CHANGE ORDER #2

Project: #1232.001 - RUSHMORE PLAZA
CIVIC CENTER MULTIPURPOSE
ADDITION - BID PACKAGE 2
Rapid City, South Dakota

Change Order No.: 2

Initiation Date: November 7, 2007

FIELD FIX DETAILS - NOC #11
RUSHMORE PLAZA CIVIC CENTER ADD'N
SAMPSON CONSTRUCTION - LINCOLN, NE

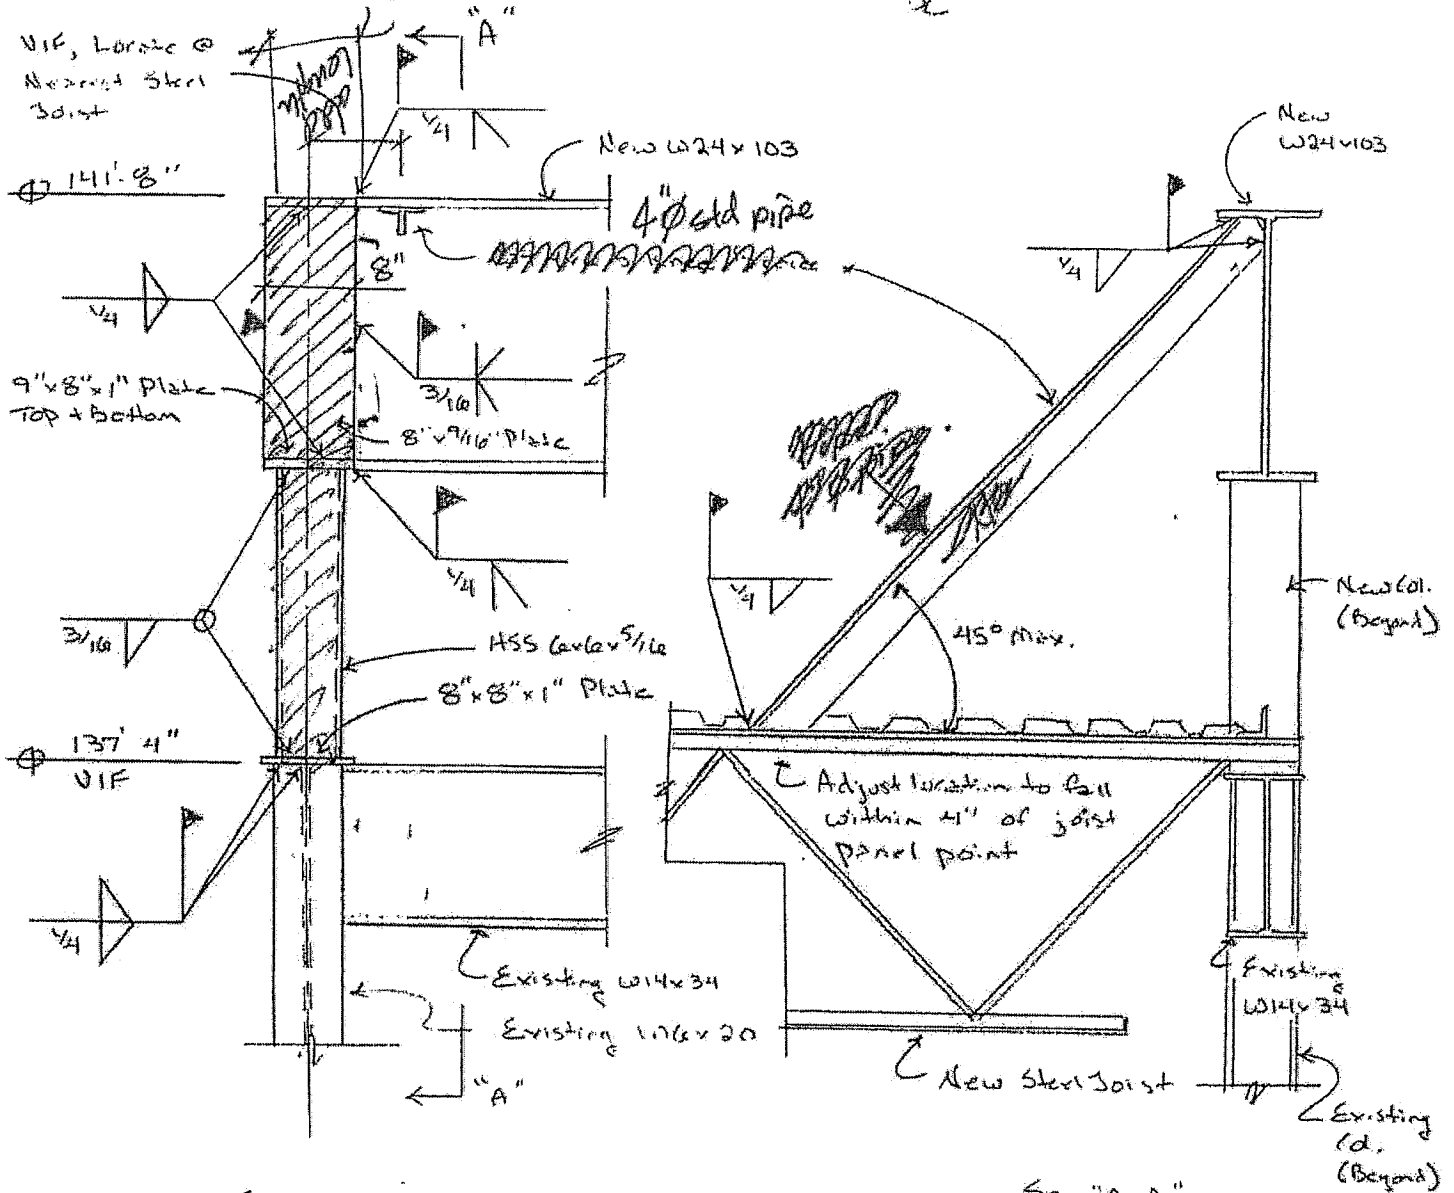
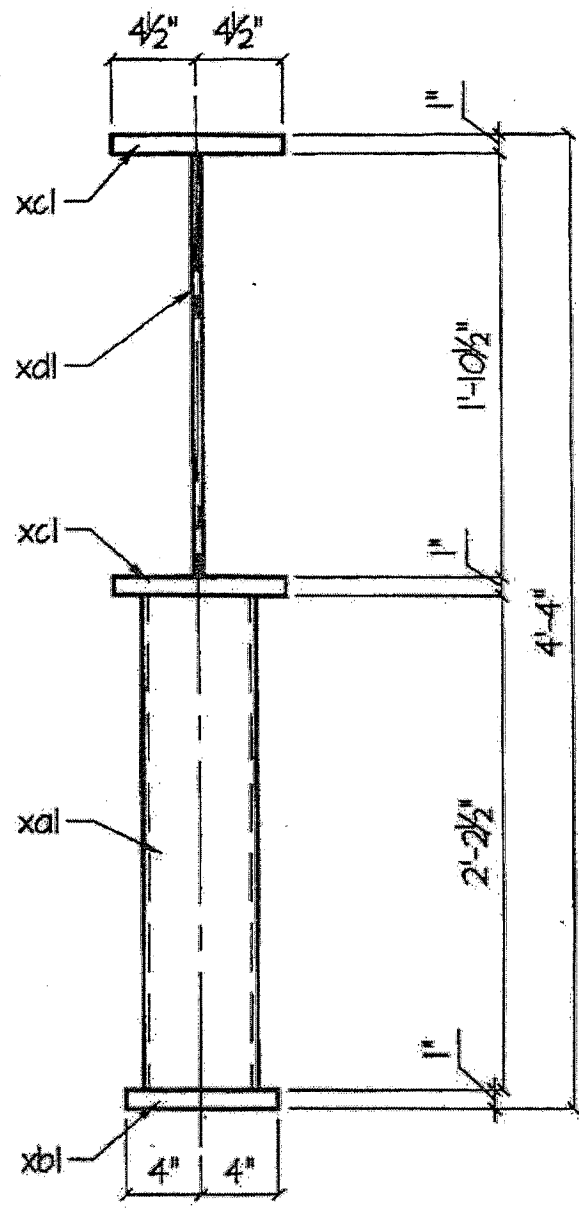
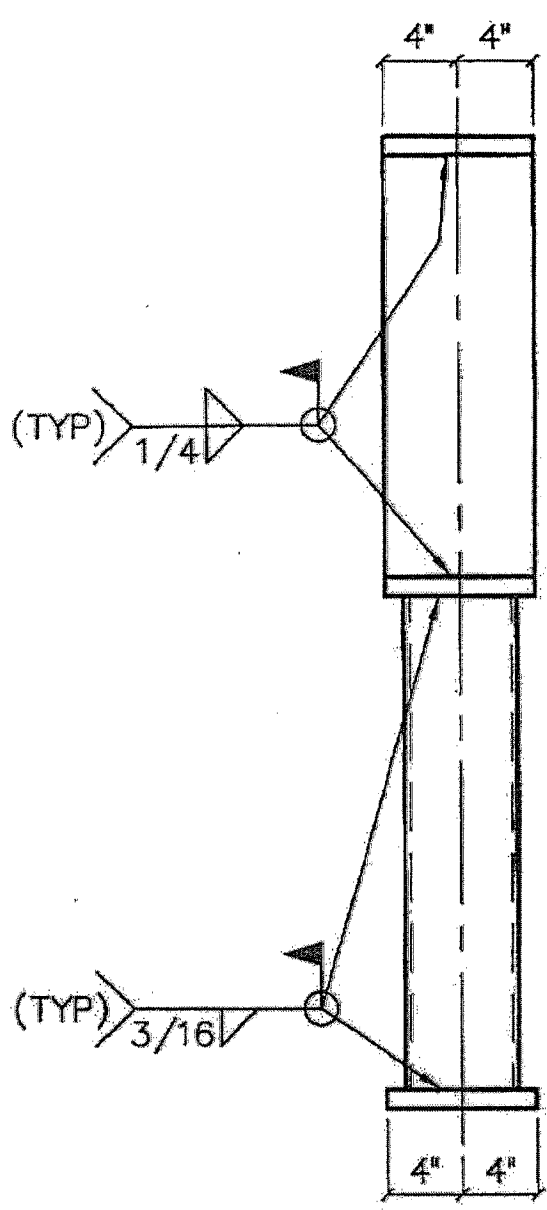
1. Provide costs, breaking out labor and materials, to provide the attached structural revisions. Include necessary roofing revisions.

Cross Section
2006-002
Ex. in to old connection
8/6/07
DL

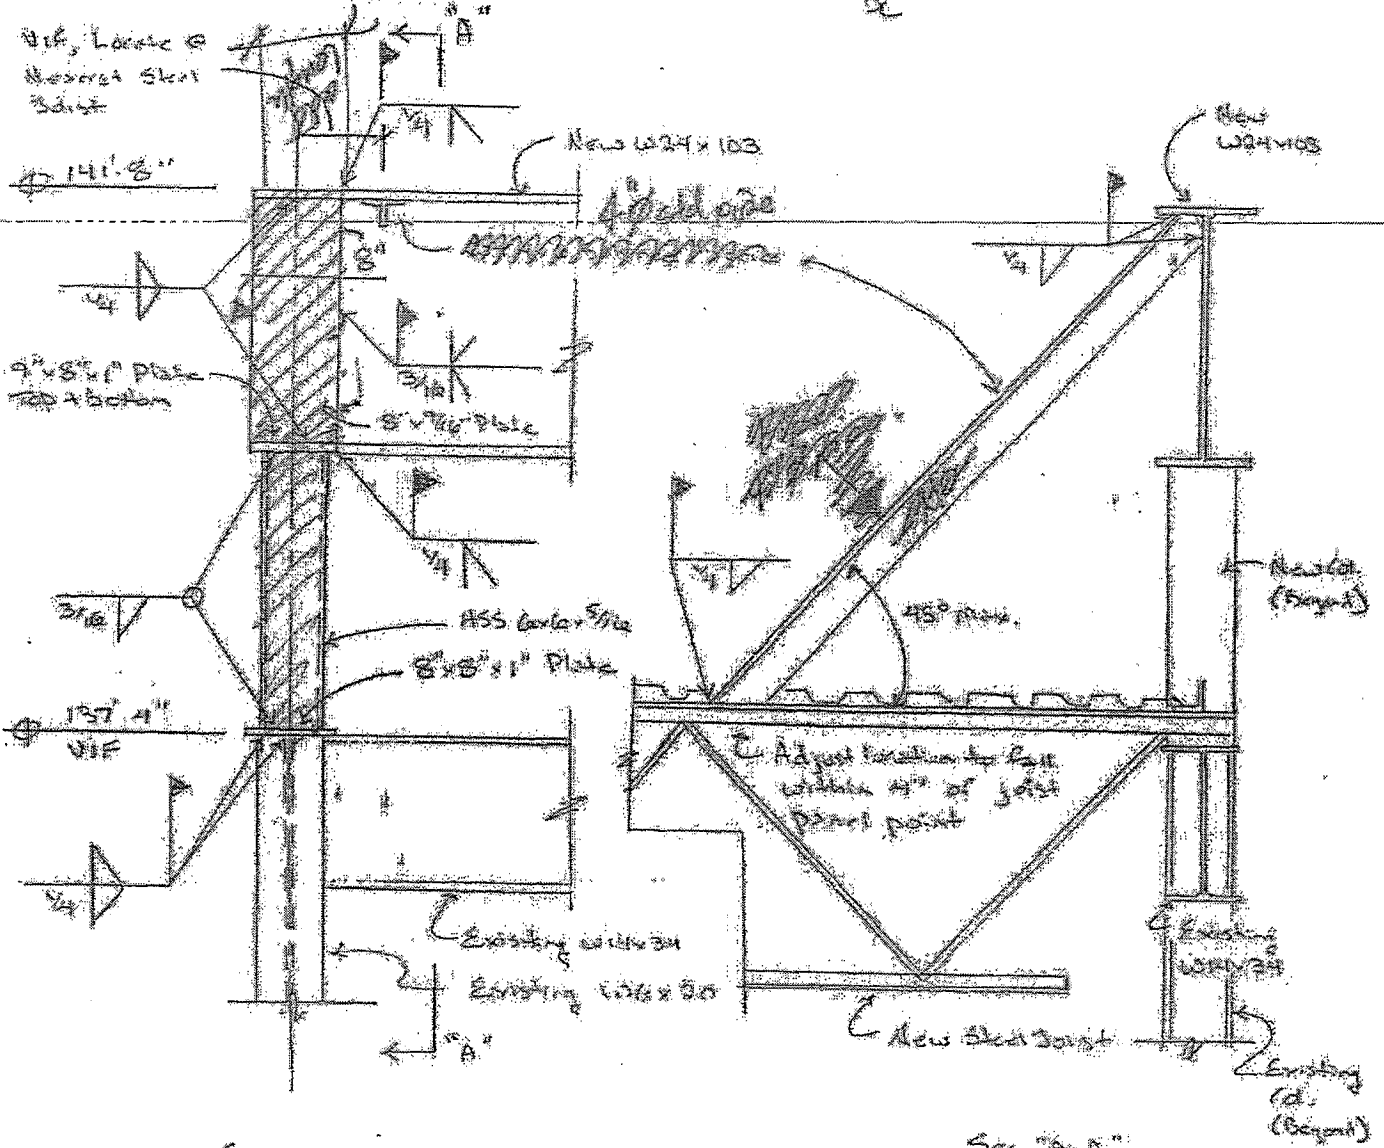
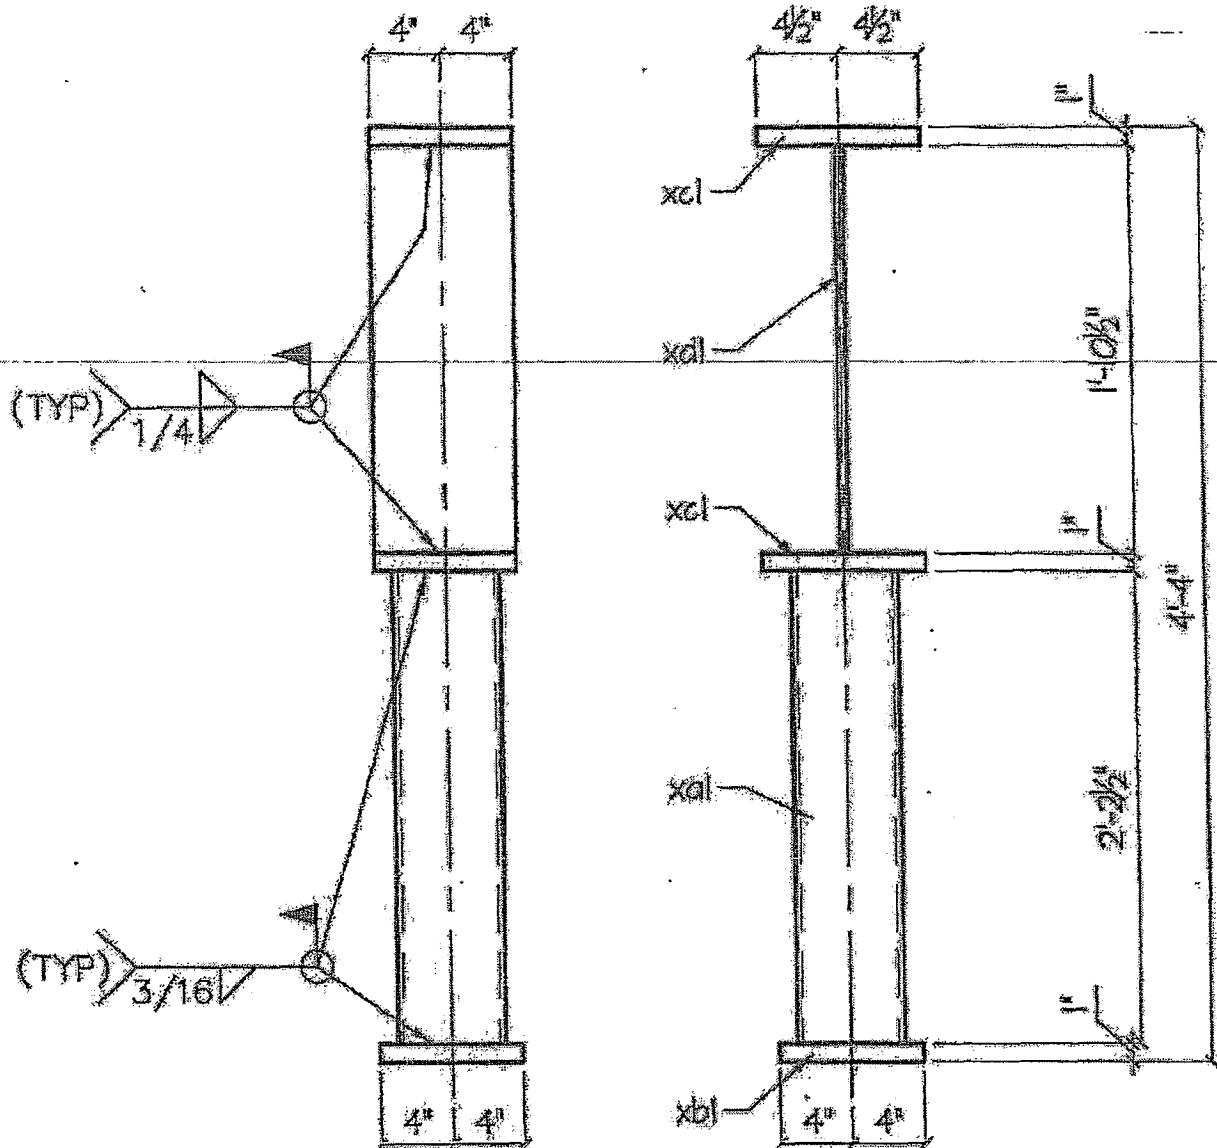
1. Provide costs, breaking out labor and materials, to provide the attached structural revisions. Include necessary roofing revisions.

ASI #3

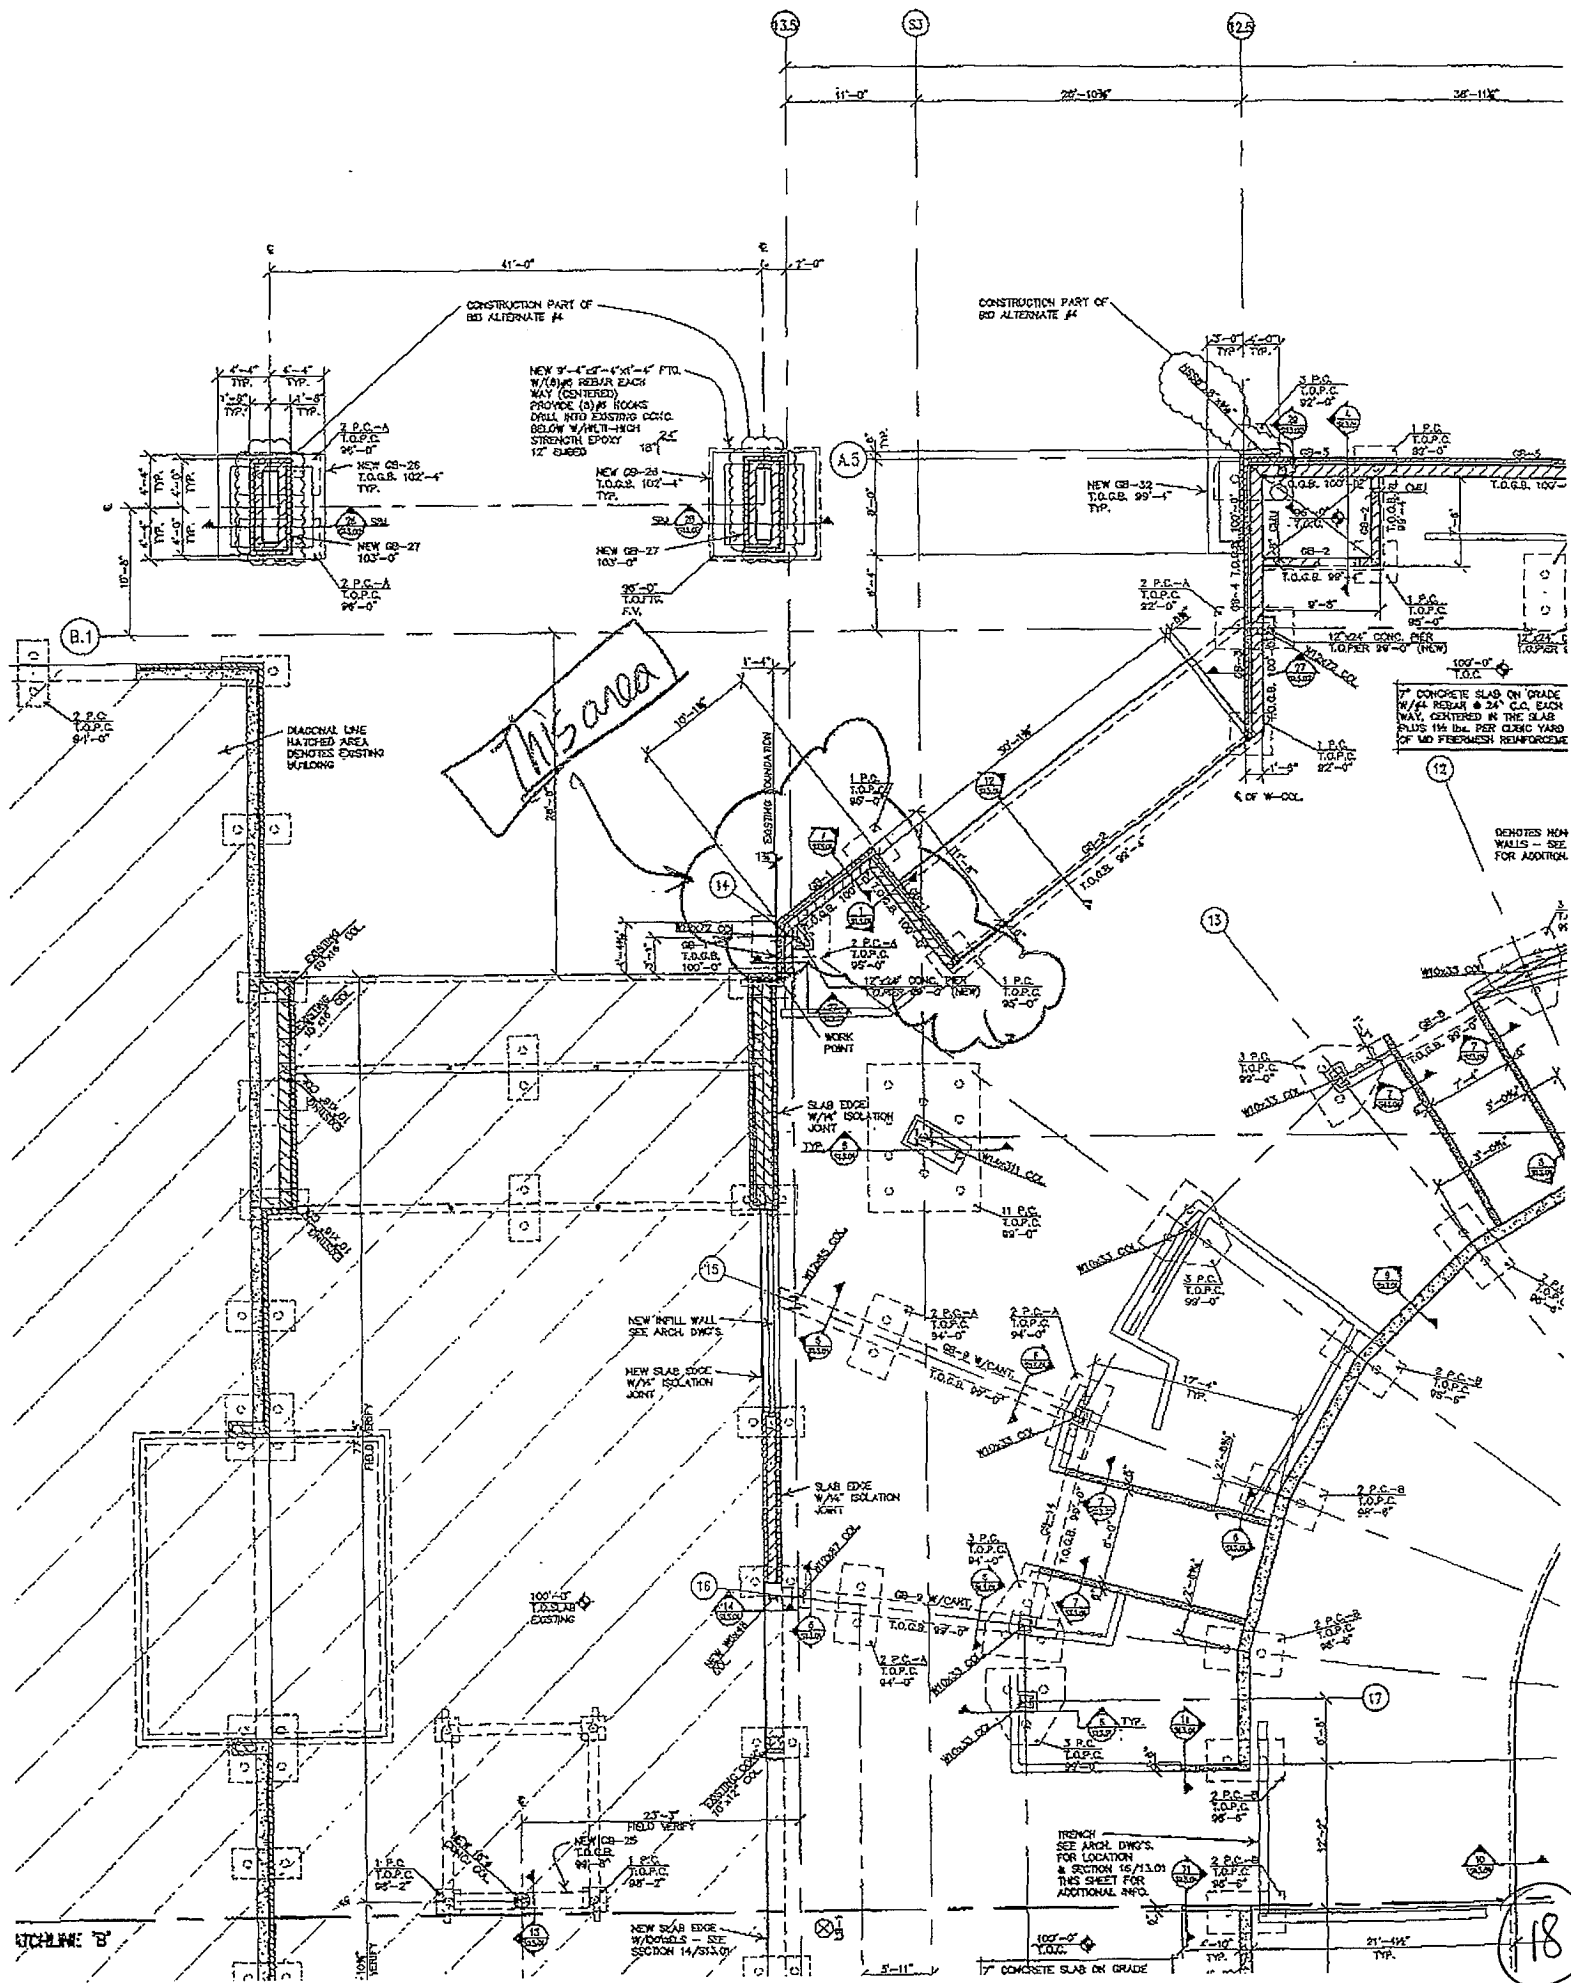
Make modifications to the existing pile caps per attached Albertson Engineering On-site Observation Report dated April 18, 2007. (Grade beam modifications will be issued under an independent ASI).

Column Location	Column Size Designed	Reported Elevation Change (Actual - Designed)	Revised Baseplate Bottom Elevation
G.2 - 23	W10x33	-7/8"	99'-1" (Lowered 1")
C.2 - 24	W10x33	-1"	99'-1" (Lowered 1")
C.2 - 9	W12x53	-7/8"	99'-1" (Lowered 1")
C.2 - 8	W12x53	-1 1/4"	99'-1" (Lowered 1")
C.2 - 7	W12x53	-2"	99'-0" (Lowered 2")
D.2 - 6	W12x65	-1 1/4"	99'-1" (Lowered 1")
D.2 - 6	W12x65	-2 1/4"	99'-0" (Lowered 2")
D.2 - 6	W14x311	-3/4"	99'-1" (Lowered 1")
L - 5	W12x65	-2 1/2"	98'-11" (Lowered 3")
J - 3	W12x72	-2"	99'-0" (Lowered 2")
H - 3	W12x72	-2"	99'-0" (Lowered 2")
G - 3	W12x87	-1 1/4"	99'-1" (Lowered 1")
B.2 - 2	W12x72	-2 1/2"	98'-11" (Lowered 3")
L - 2	W12x72	-2 1/2"	98'-11" (Lowered 3")
